PROPOSED PLAN OF DEVELOPMENT

Lots 291 & 9001
Cancelling Lot 9001 on SP280605

PLANS AND DOCUMENTS
referred to in the PDA APPROVAL
29 APR 2016
MEDQ

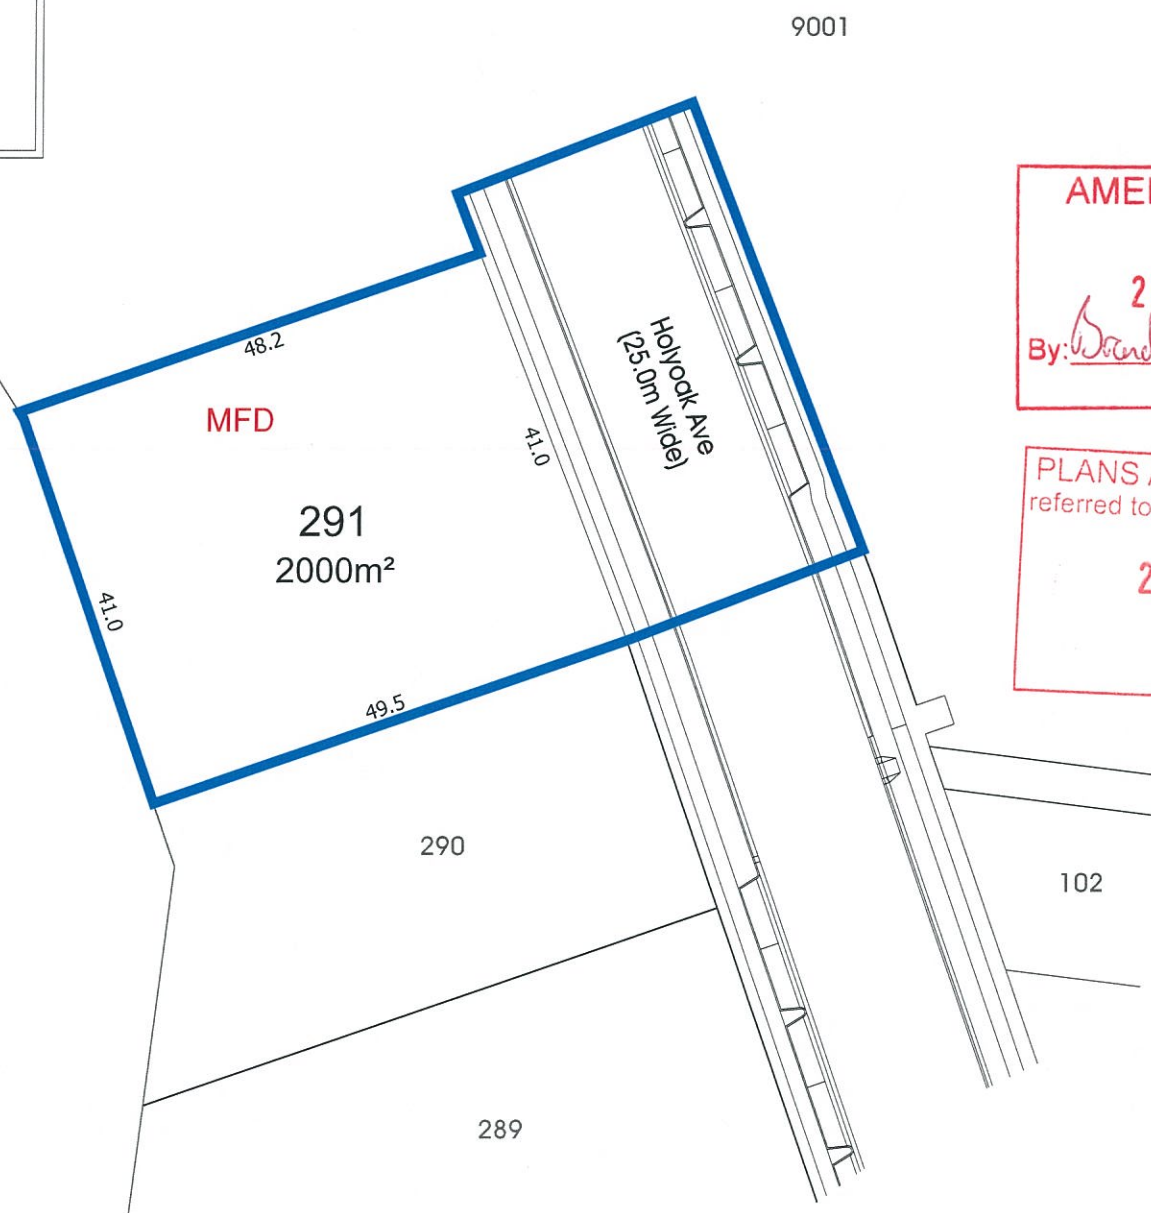
AMENDED IN RED
29 APR 2016
By: *David Duda* (name)
MEDQ

- Letterboxes clearly visible and identifiable from the street;
 - Clearly identifiable and addressed front doors and ~~undercover~~ ^{undercover} point of entries;
